RE: ISFA Guaranteed Rate Field – Sound Room Cooling Project
Engineer's Project Number: 23504
Addendum Number: 01

This Addendum consists of additions and/or modifications to the plans and/or specifications to the bidding and contract documents dated January 23, 2025. The changes to these documents are only in the manner and to the extent stated herein. All drawings have “Issued for Addendum 1” and “01/31/2025” on the sheet. Changes are bubbled and tagged with revision Delta 1. This Addendum supersedes any oral or written information previously delivered. Contractor to acknowledge receipt of this Addendum 1 on the Bid Form; failure to do so may subject bidder to disqualification.

300 LEVEL

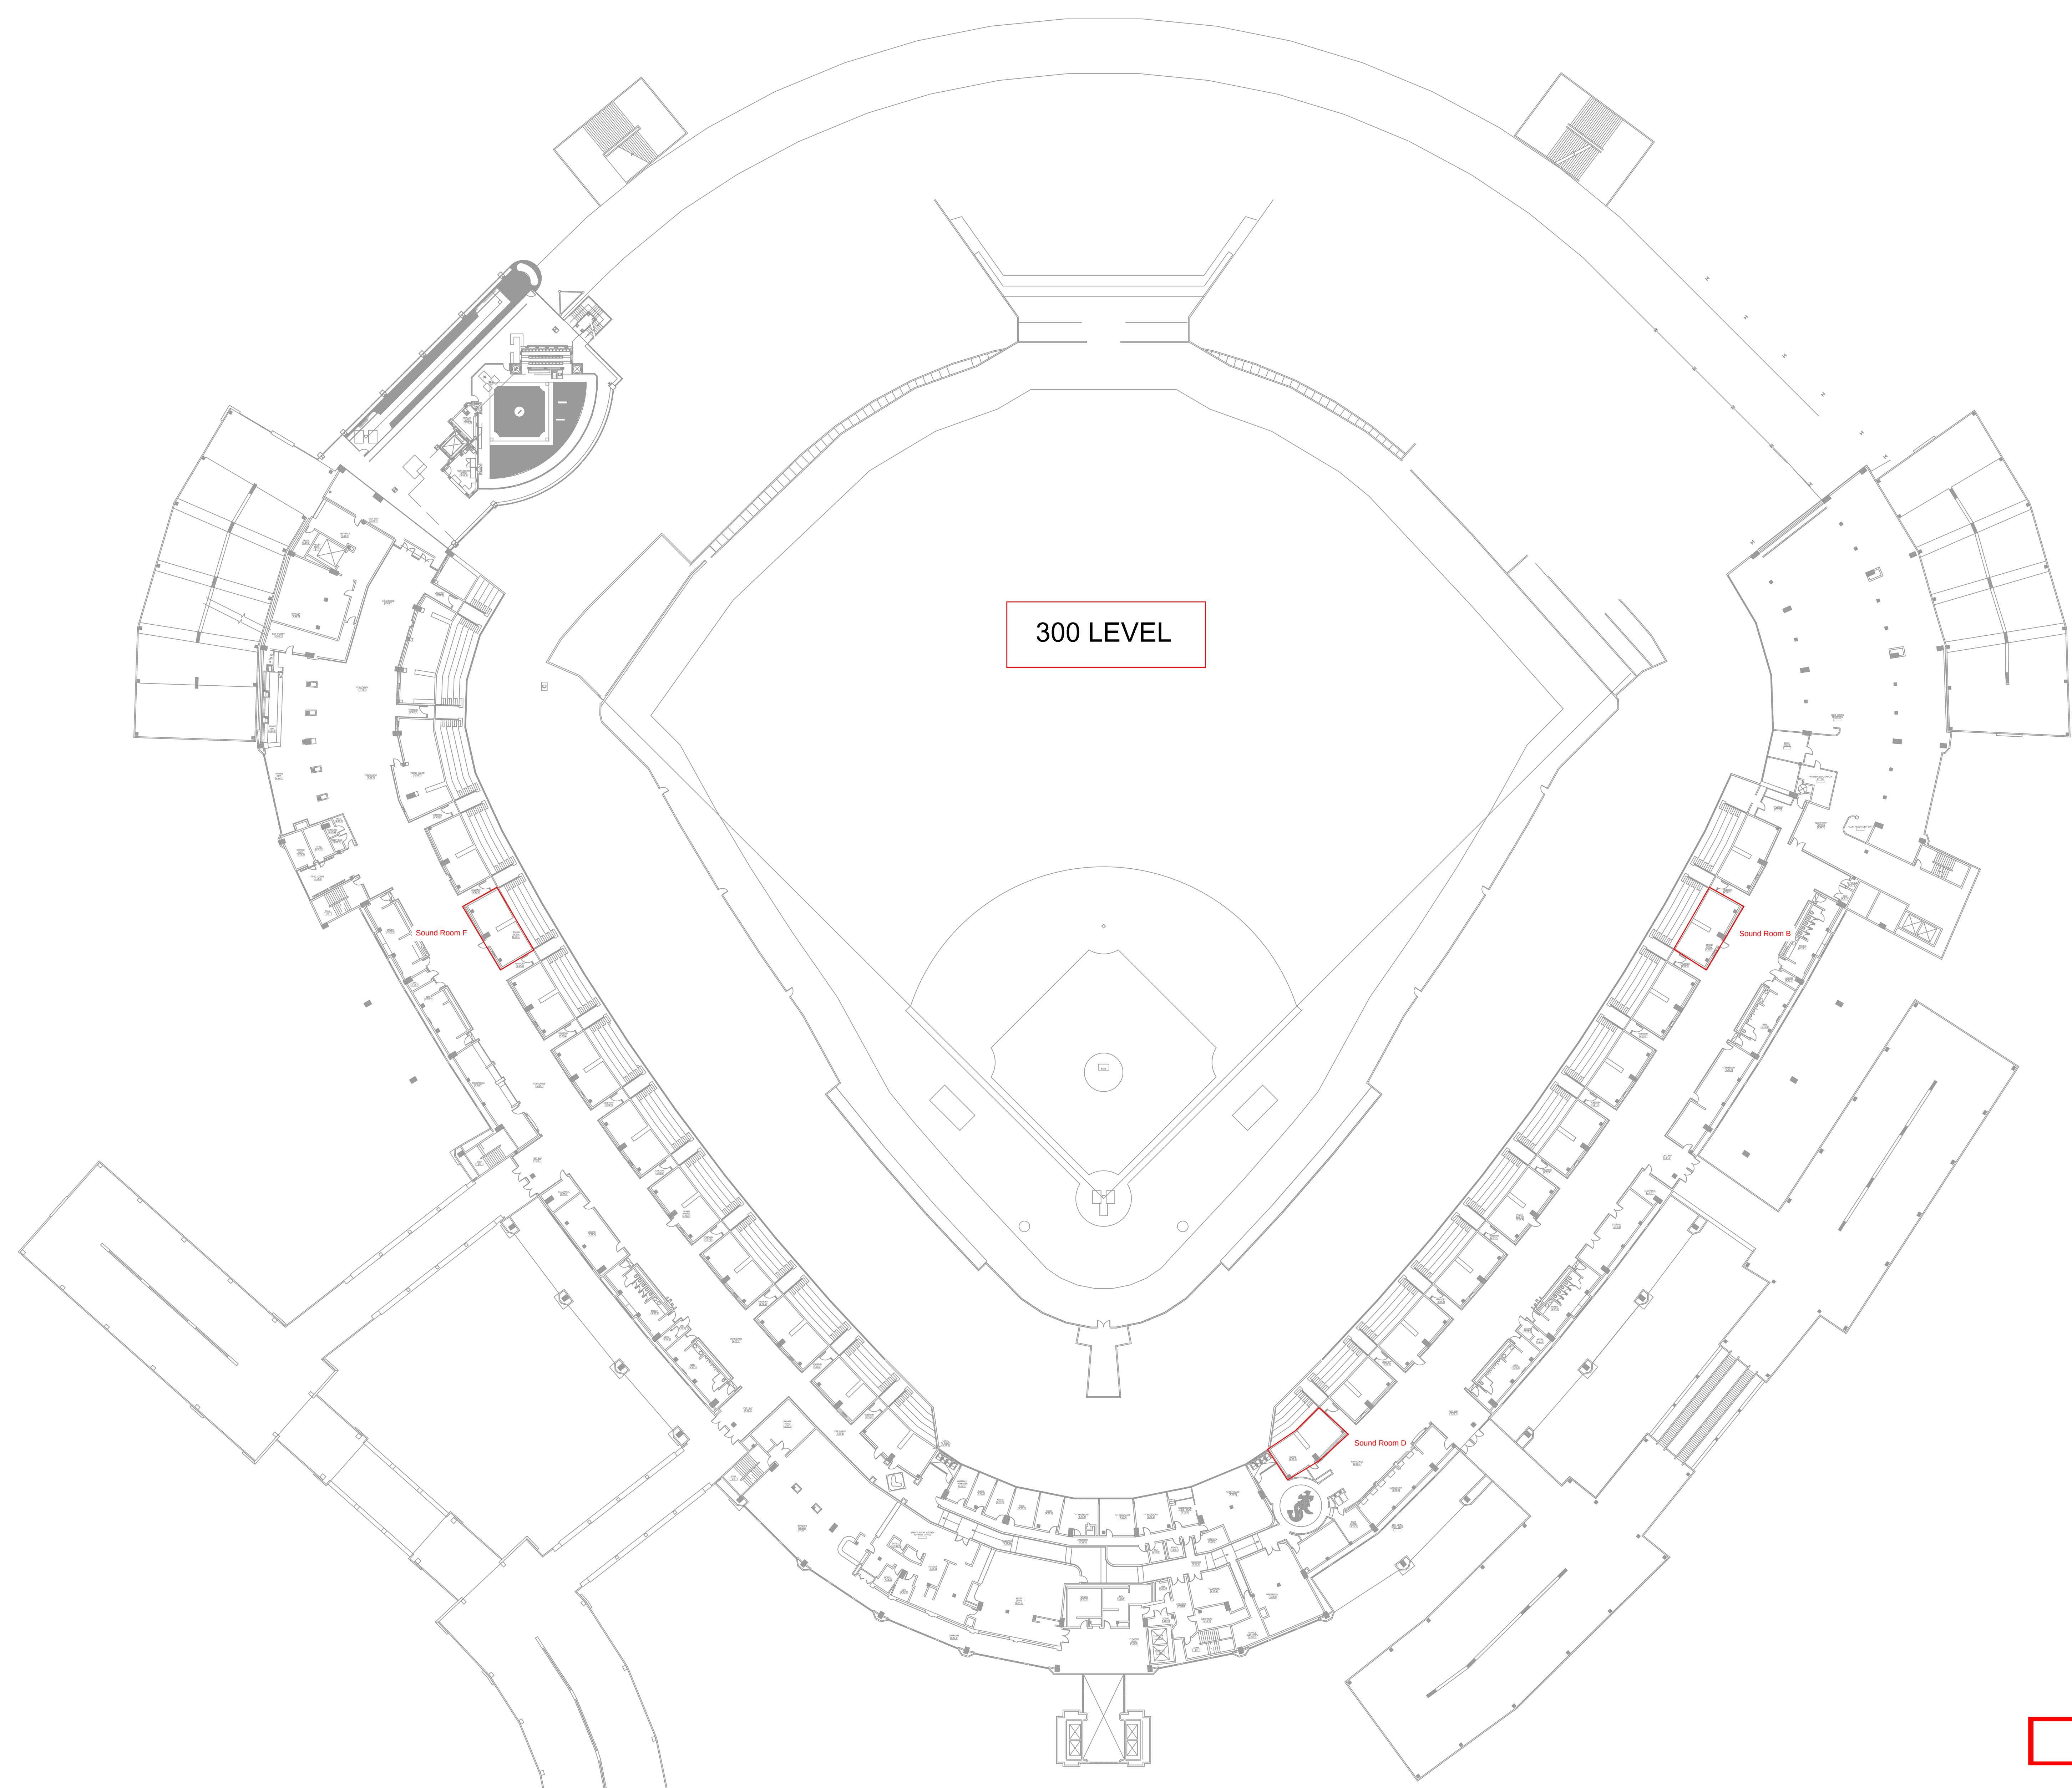
Connect new 1-1/4" drain from
Sound Room above into existing
condensate main serving suite
FCUs, located in corridor on
floor below.

Connect new 1-1/4" drain from
Sound Room above into existing
condensate main serving suite
FCUs, located in corridor on
floor below.
